LIDL GREAT BRITAIN LTD
OLDLANDS FARM
BOGNOR REGIS

AS-BUILT SURFACE WATER DRAINAGE,
CONDITION 10

Report Reference:	LIDLBOGNOR.10-DTN
Project Code:	SF/LIDLBOGNOR.10
Prepared by:	CG
Approved by:	SF
Issue Date:	November 2021
Status:	1st Issue

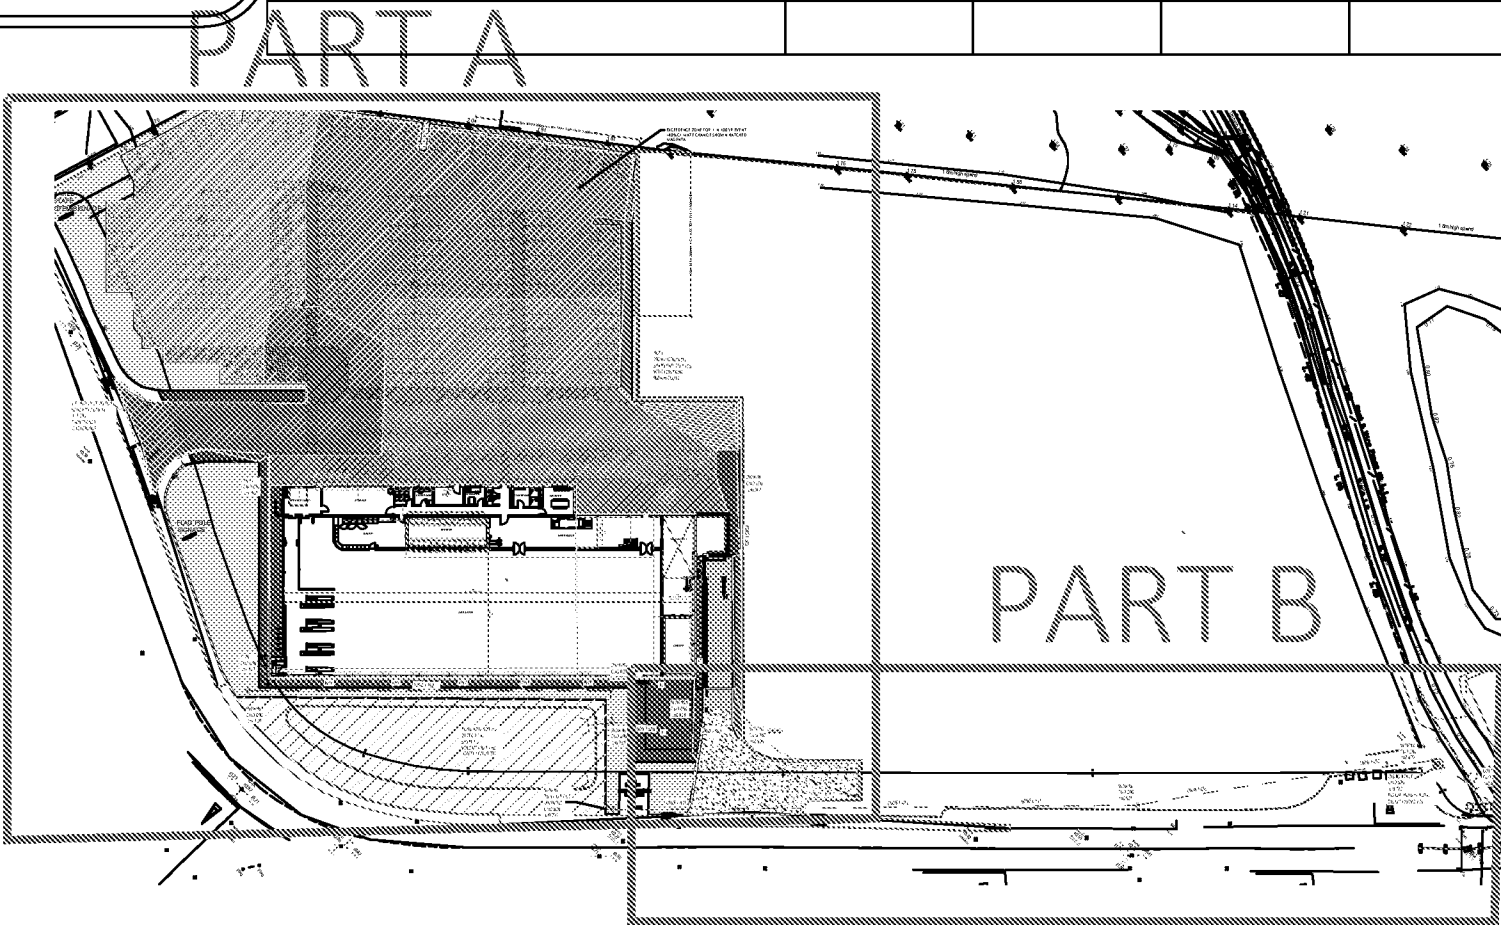
- 3.10 The as-built network design follows the design principles set out in the approved scheme. However, the exact configuration of the drainage elements has been amended to suit the more accurate information that comes about while undertaking a detailed civils and drainage design. The differences are as follows:

- ✦ The roof of the store falls towards the rear, whereas the approved scheme split its evenly between front and rear.
 - ✦ The proposed car park levels design has altered so the gully positions, pipe layouts and diameters upstream of the detention basin have been amended.

- ✦ The as-built final outfall into Oldlands Farm ditch is 150mm higher than the approved scheme, which has amended the final levels and gradients of the 600mm pipes downstream of the basin. This makes negligible difference to how the overall network operates.

- 3.11 Although the pipe runs do not exactly match the approved scheme, the pipe configuration, diameters and gradients for the as-built design network are acceptable.

- 3.18 This low point of 1.99m AOD is below the simulated top water level in the detention basin and drainage network during the critical 1in100 year storm event (including climate change). Therefore, a 56 metre long berm was constructed on the perimeter of this section of the car park to ensure surface water run-off is contained on site. The top of the berm is set at 2.40m AOD, which is above the critical water level for the 1in100yr+CC storm. The berm is shown on the as-built drawing in Appendix A
